MONTPELIER DEVELOPMENT REVIEW BOARD REPORT

FINAL SUBDIVISION REVIEW

Address: 81 North Street

Application # Z-2019-0140

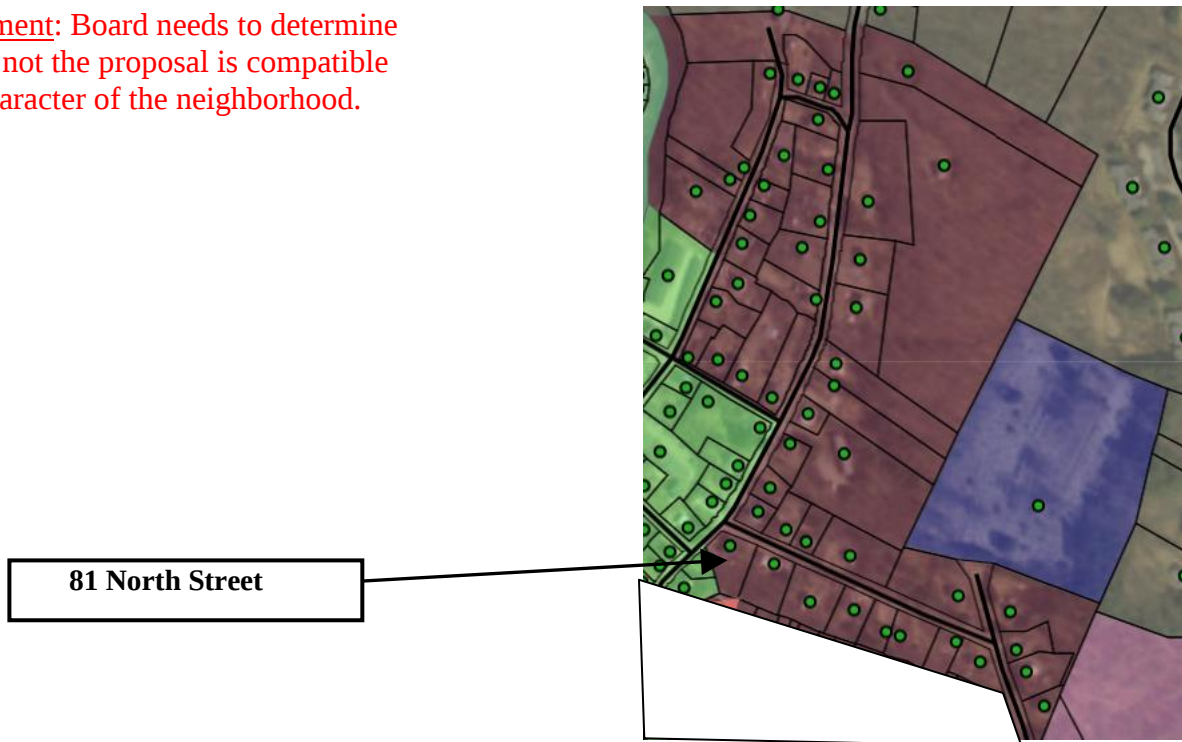
- not strip development.
- b. This is an infill subdivision, where the future intended use is residential (up to three units) on what is now a large side-yard. Although there are larger parcels within the Neighborhood, this particular parcel appears to be suitable for an infill subdivision – given the terrain. See image below – parcels shaded maroon are in the subject Neighborhood.

Staff Comment: Board needs to determine whether or not the proposal is compatible with the character of the neighborhood.
